Product/Process Change Notice - PCN 23_0180 Rev. -

PCN Title:	New Tray Design for BGA Package
Publication Date:	20-Nov-2023
Effectivity Date:	22-Feb-2024 <i>(the earliest date that a customer could expect to receive changed material)</i>
Revision Description:	Initial Release.

Change tray 50-8068 to tray 50-8001 for BGA devices LTM4633 / LTM4634 / LTM4628 / LTM4620 / LTM4620A / LTM4641.

1.0 Dimension comparison

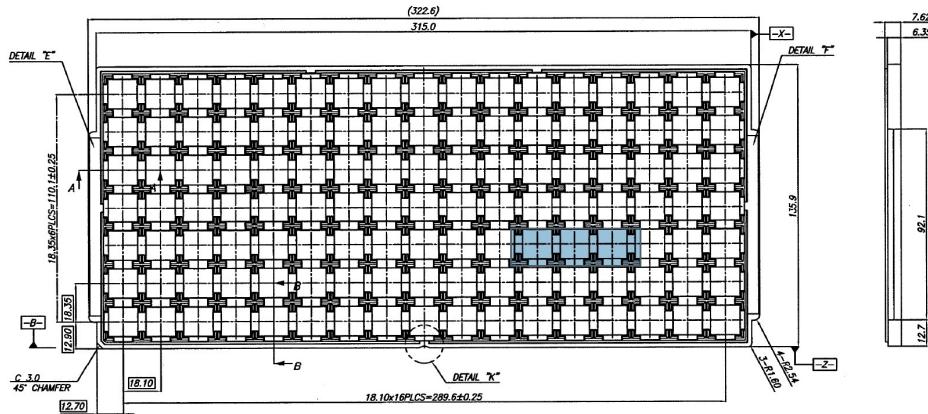
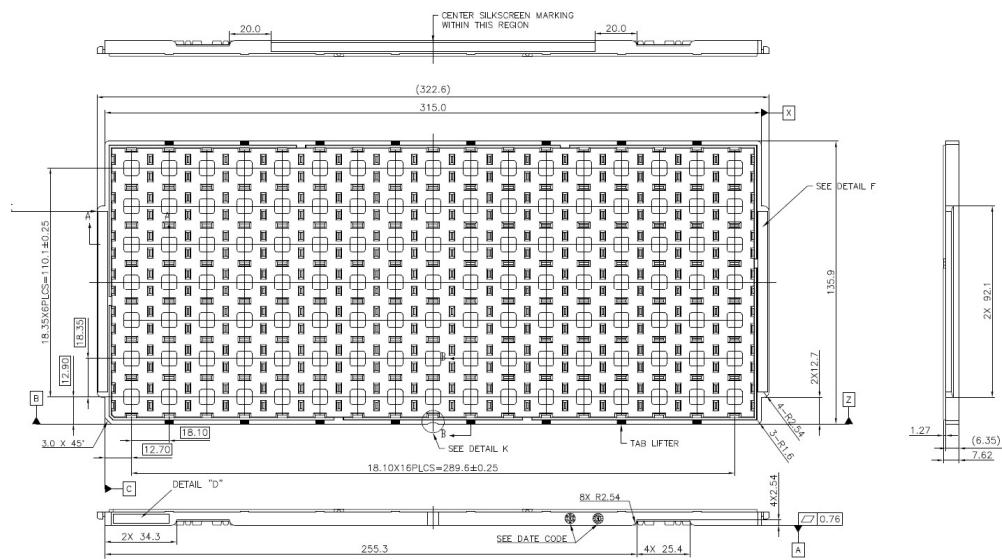
There is no significant change to the dimensions of the tray.

Note: The tray 50-8068 and 50-8001 not stackable with each other due to pocket tray wall design is different. There will be a gap in between both tray when 50-8068 stack on top of 50-8001 or 50-8001 stack on top of 50-8068.

2.0 Physical differences

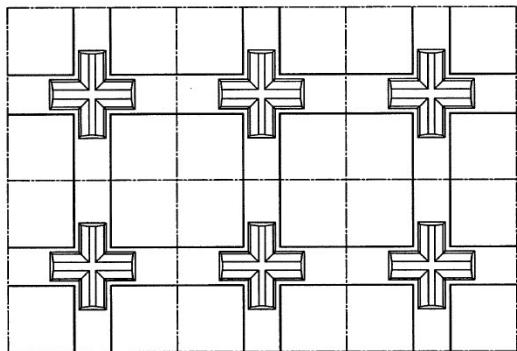
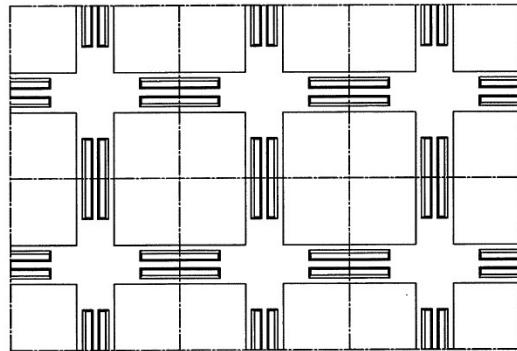
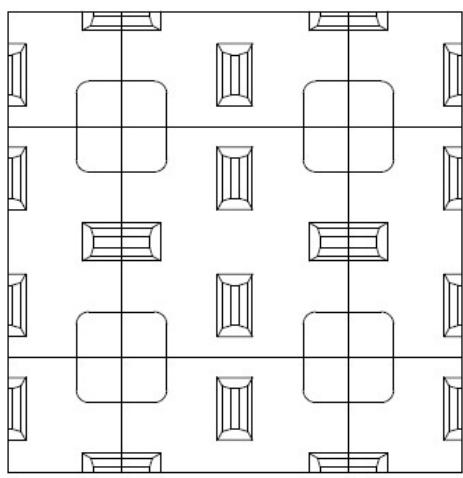
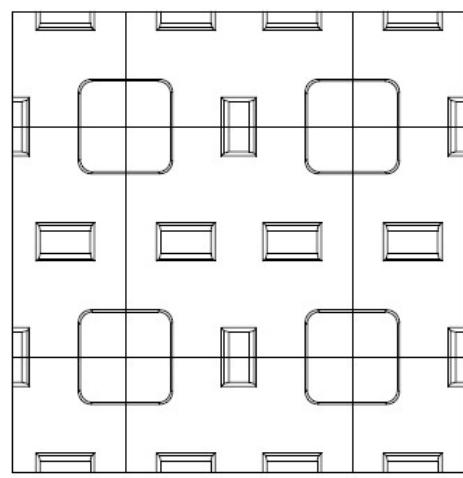
Both trays have silk screen printing indicating the tray part number, 8001 for 50-8001 and 8068 for 50-8068.

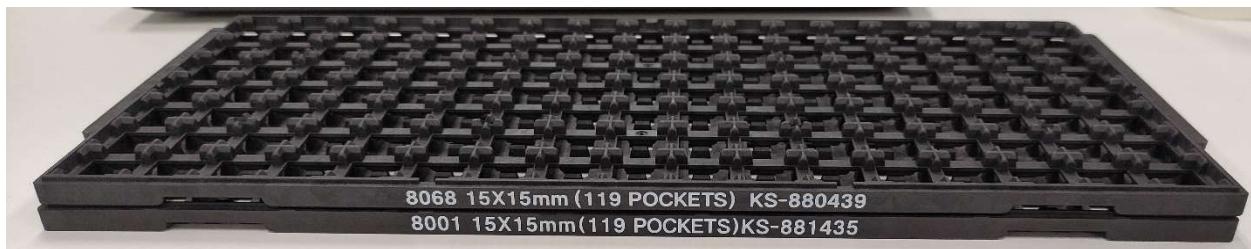
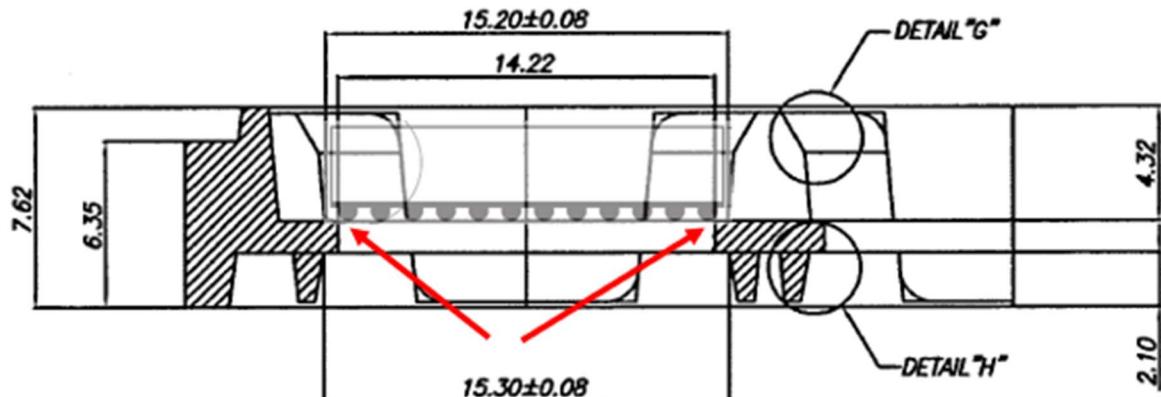
Tray 50-8068 solder ball at the perimeter of the unit will be sitting on the edge of the tray pocket.

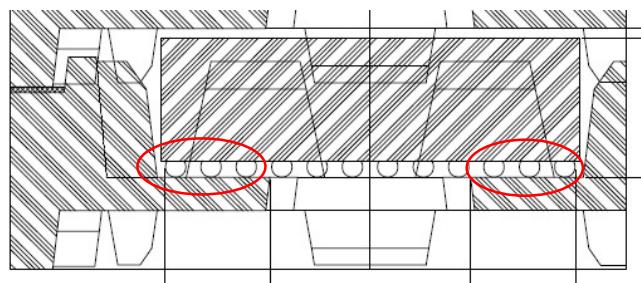
Tray 50-8002 solder ball 3 row on the left and 3 row on the right of the unit will be supported by the tray.
